TH347-01F04 Addendum to DA Acoustic Report (r5)

Lendlease

North Plot, The Darling Exchange - Addendum to SSDA10 Acoustic Report

Loading Zones C and F removed

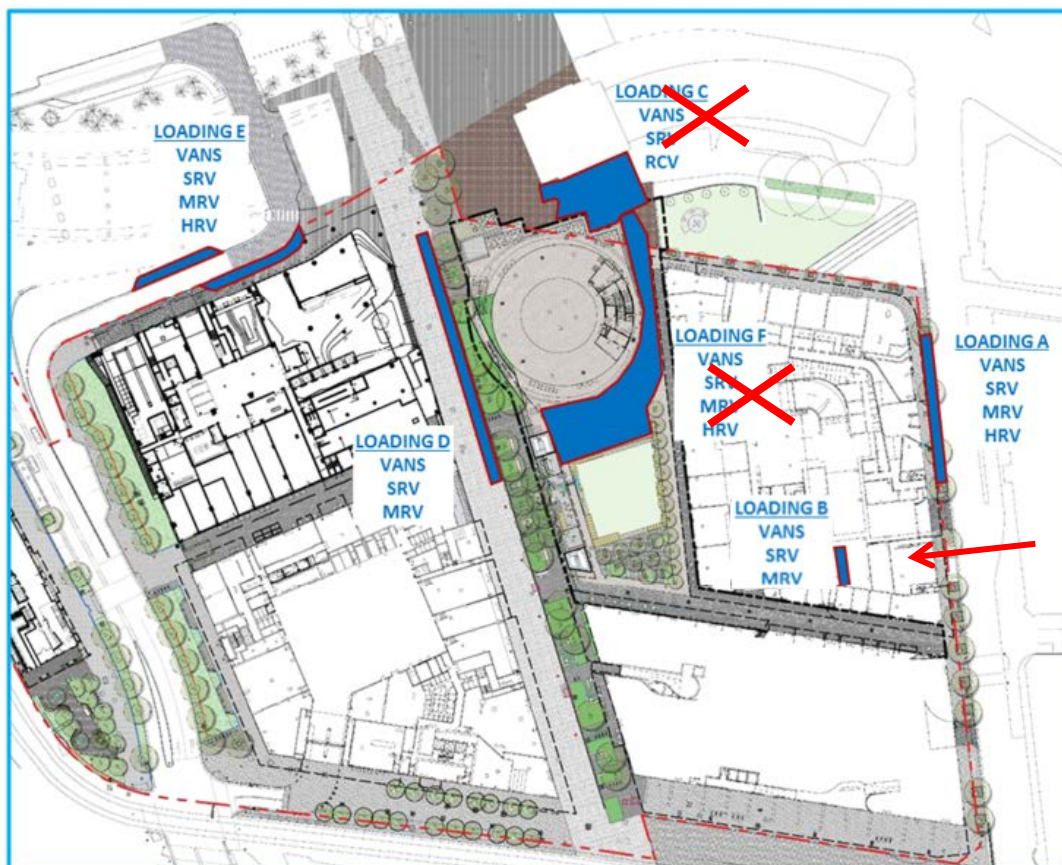
Query: *The Noise and Vibration report (Appendix P) includes a loading matrix that suggest loading times up to 8pm, however, the loading service area assessment suggests a limit of 10pm. Provide confirmation of exact expected loading times, whether any loading is proposed after events ending at 10pm in the square and how the noise from any such loading will be managed/minimised if proposed.*

Query: *Confirm what additional mitigation measures can be used to reduce the impact of noise from outdoor events within the public square on residential properties.*

Response: The loading strategy has been amended since the lodgement of the Development Application. Loading for the North Plot will now be serviced through the North East Plot (Loading area B) with loading for the public domain and events now occurring primarily through the boulevard (Loading Area D) with support via Theatre Access Lane (Loading Area E). This has removed loading zones F and C directly outside the North East Plot and Novotel that were identified in the original report as sensitive with regard to noise sensitive receptors.

As noted in the original report Loading Area D will also need to be managed with regard to potential impacts within the Darling Square development. In particular, the SW Plot and SE Plot will need to be considered. Medium and large scale events will require future approvals with Place Management NSW (formally known as SHFA). Attached to the detailed application on an event by event basis, there will be a specific Plan of Management provided which will deal with key acoustic mitigation measures for event types. A general Plan of Management is provided with this RTS that recommends bump out for events finishing after 10pm to occur the next morning to minimise impact on surrounding properties.

Figure 1: Up to 10pm operation

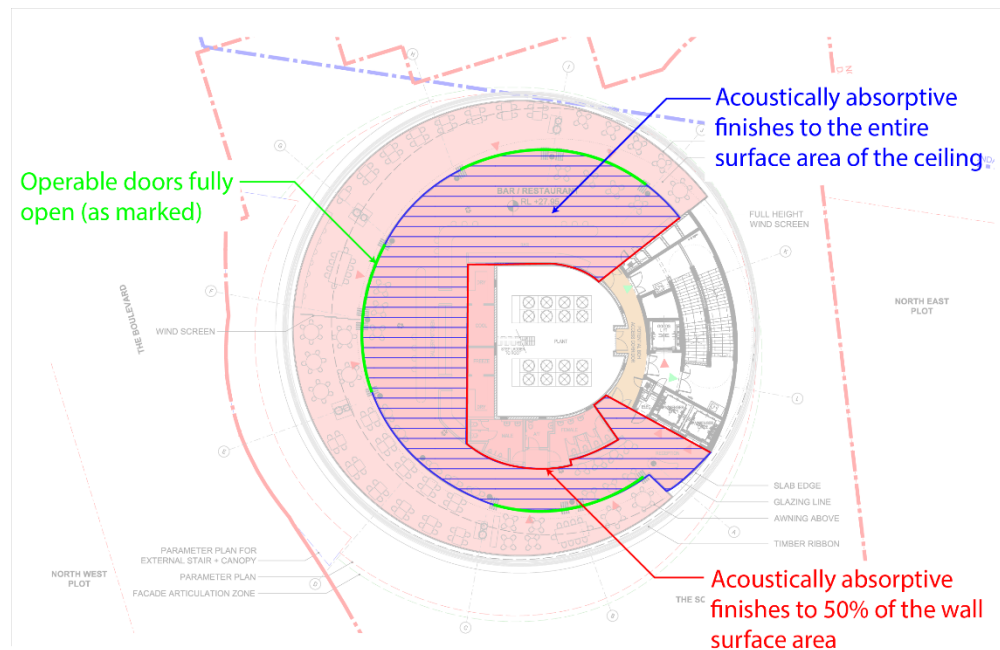
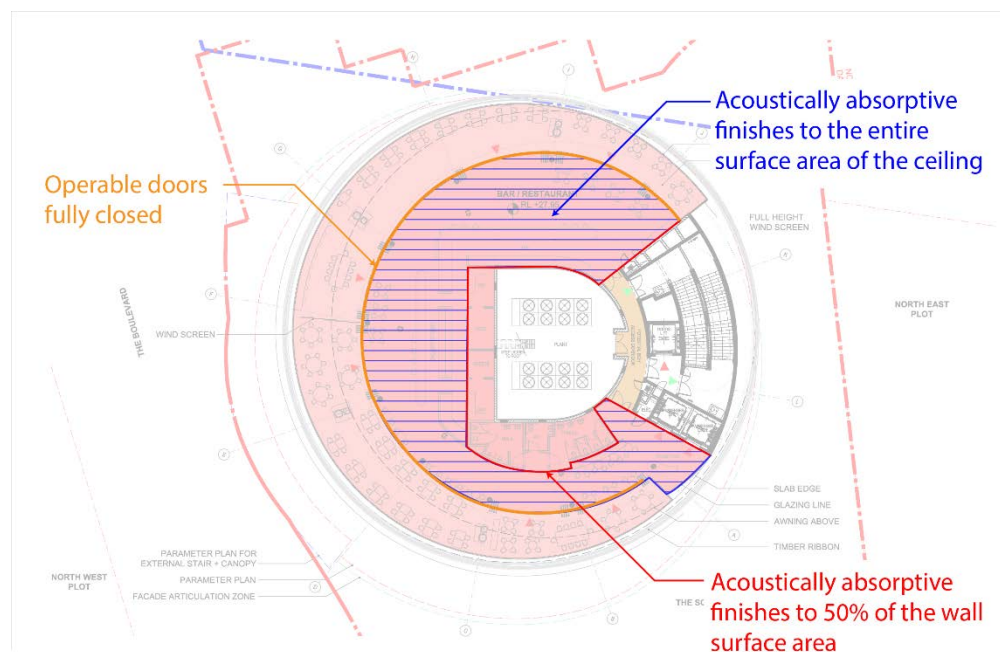
1. Operational management up to 10pm

It is recommended that the following acoustic measures are incorporated into the future fit out during detailed design to enable outdoor areas to be fully occupied up to 10pm with a maximum of 280 patrons and indoor areas to be fully occupied with a maximum of 120 patrons to ensure compliance with the CoS Council's Standard Conditions of Consent for licensed premises. We recommend the absorptive material achieve a minimum NRC rating of 0.9.

Acoustically absorptive finishes to be applied to:

- The entire surface area of the ceiling with the exclusion of kitchen and bathroom areas
- Acoustically absorptive finishes should be provided to 50% of the internal wall surface area (ie. kitchens and bathroom walls)

100% of the operable facade could be open with the implementation of sound limiting devices. If sound limiting devices are not implemented during detailed design, only 50% of the operable facade could be open.

Figure 2: 10pm - 11pm operation mark-up

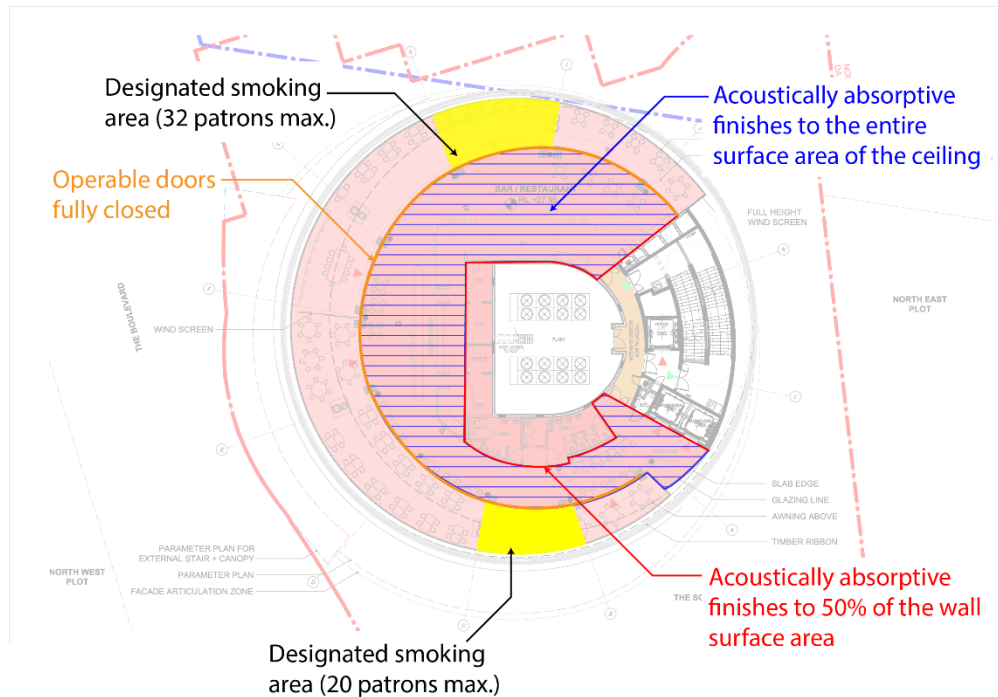
2. Operational management 10pm-11pm

Between 10pm - 11pm, operable doors are to be fully closed and outdoor areas can be fully occupied with a maximum of 280 patrons.
